TECHNICAL SERVICE BULLETIN

75-A-6

Austin MG

MIDGET 1500 CC OVERHEATING

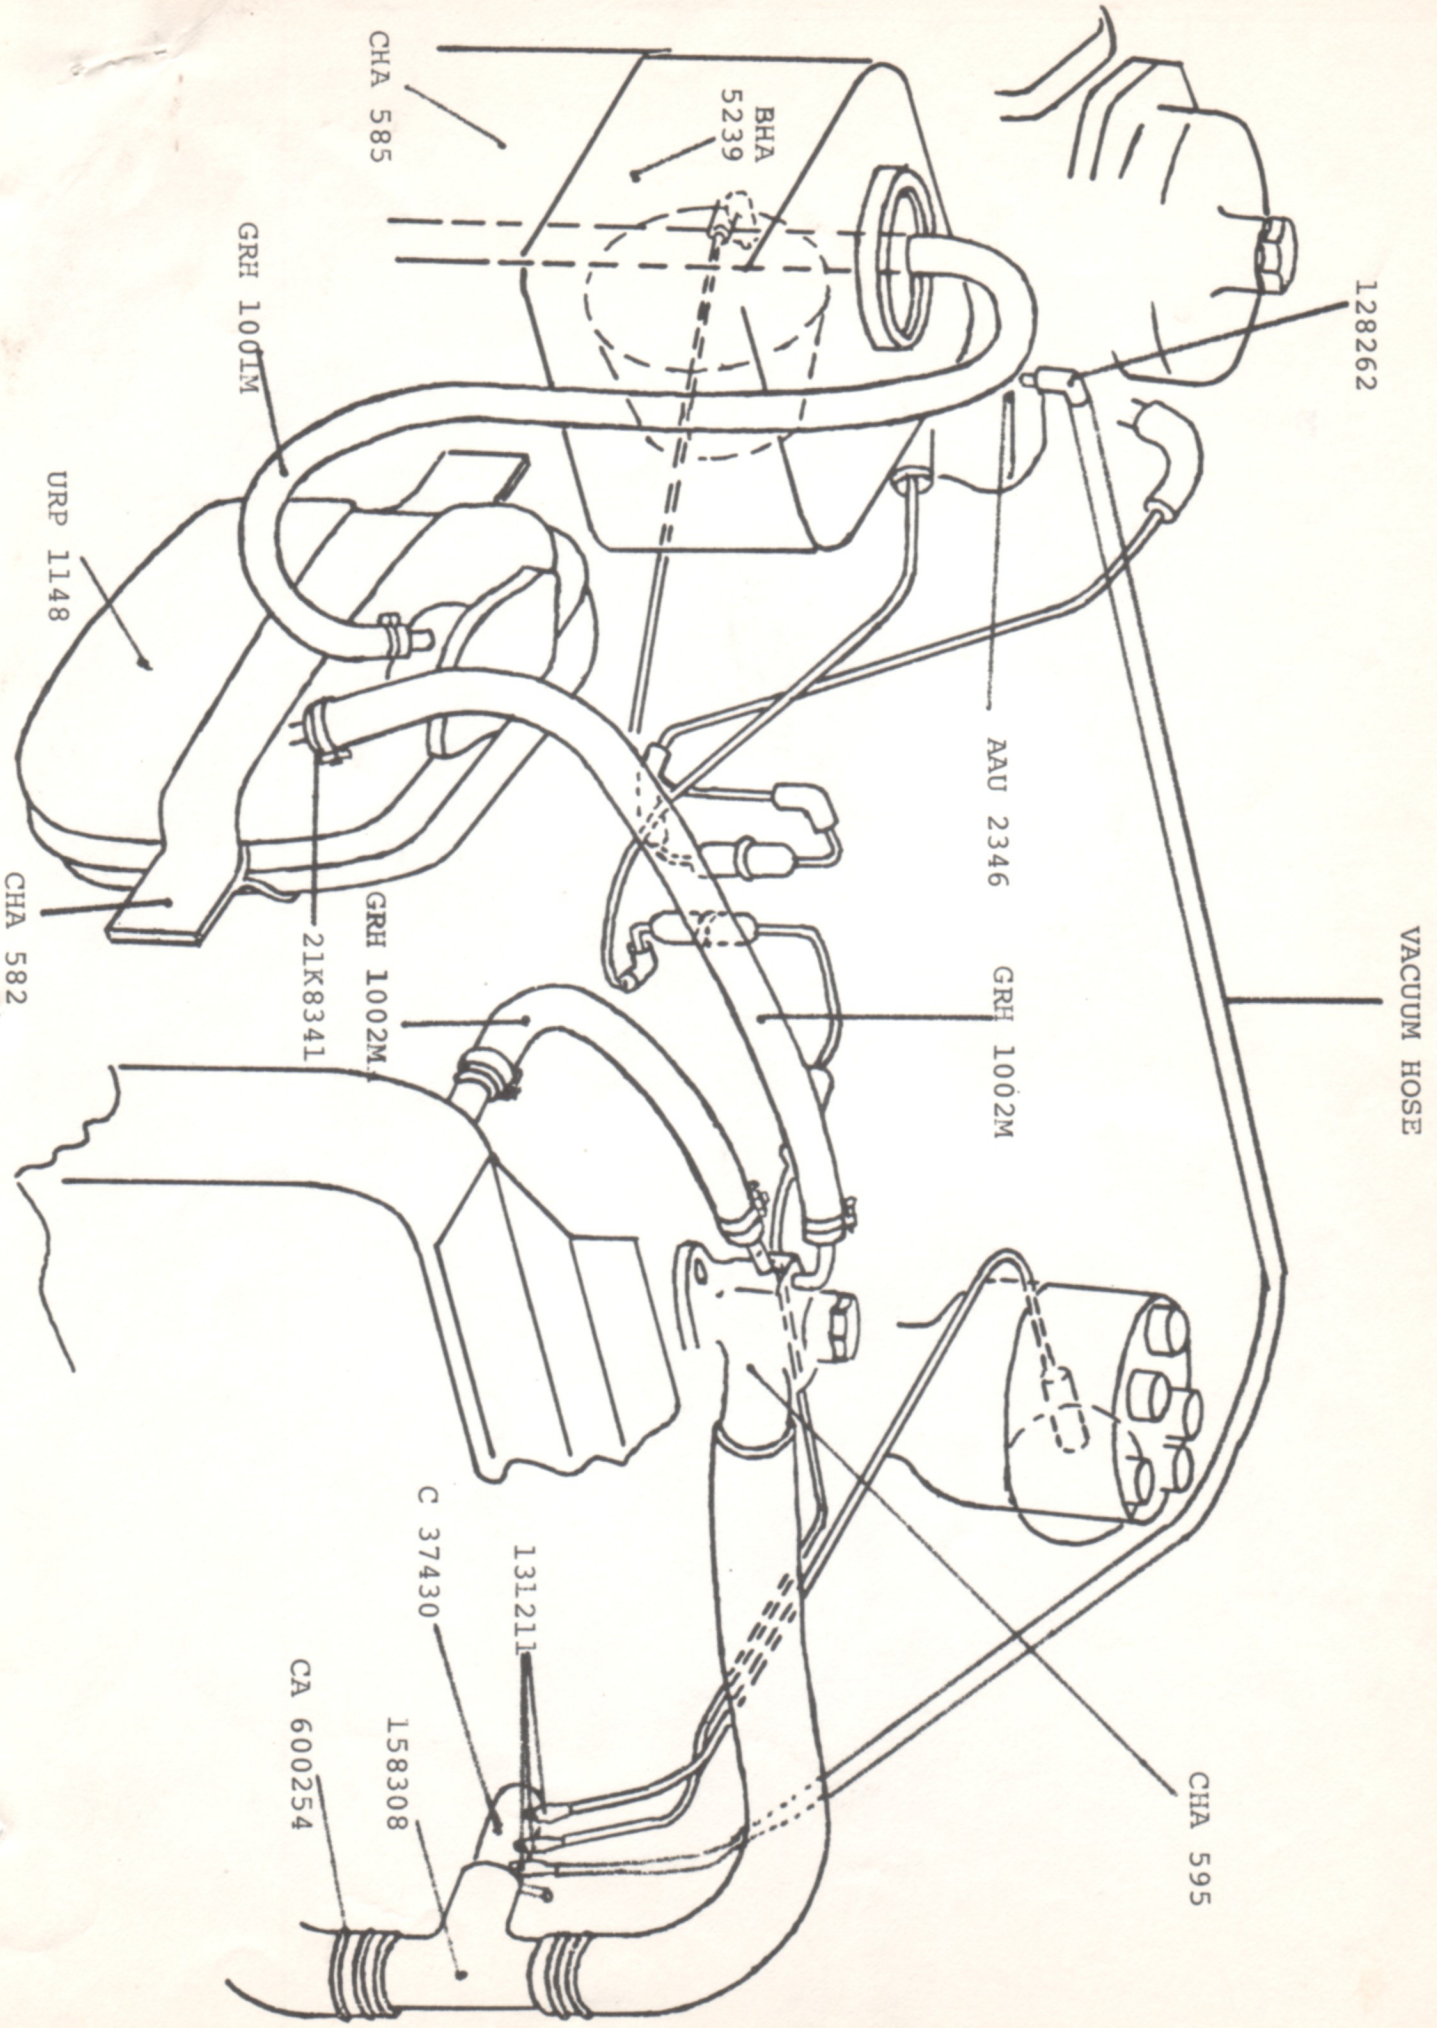
1. Remove and discard the front number plate bracket and plinth assembly. Relocate and mount the front number plate to the center of the bumper, using self-tapping screws.
2. Reposition both horn assemblies by simply bending the mounting bracket upwards and through 90°.
3. Install thermo-vac switch, Part No. C-37430 with 'T' sleeve adaptor, Part No. 158308 in the top radiator hose as shown.

NOTE:- (Remove approximately 1 1/4" from the existing hose to accomodate the 'T' sleeve.)

4. Remove the decell valve from the carburettor and replace with externally vented valve, Part No. AAU-2346.
5. Remove and discard the existing expansion tank and replace with metal type, Part No. URP-1148, using the existing bolts and spacers and new brackets supplied, Part No. CHA-582.

NOTE:- The pressure cap supplied with the metal tank has a double seal, and therefore is not interchangeable with the original cap which should be discarded.

6. Install bracket, Part No. CHA-585 and no-loss bottle, Part No. BHA-5239, utilizing the right-hand upper shock absorber support plate bolts.
7. Remove and discard the thermostat housing and install modified housing, Part No. CHA-595.

8. Connect the vacuum and water hoses as shown in overall illustration.

NOTE:- Vacuum hose will have to be cut to length.
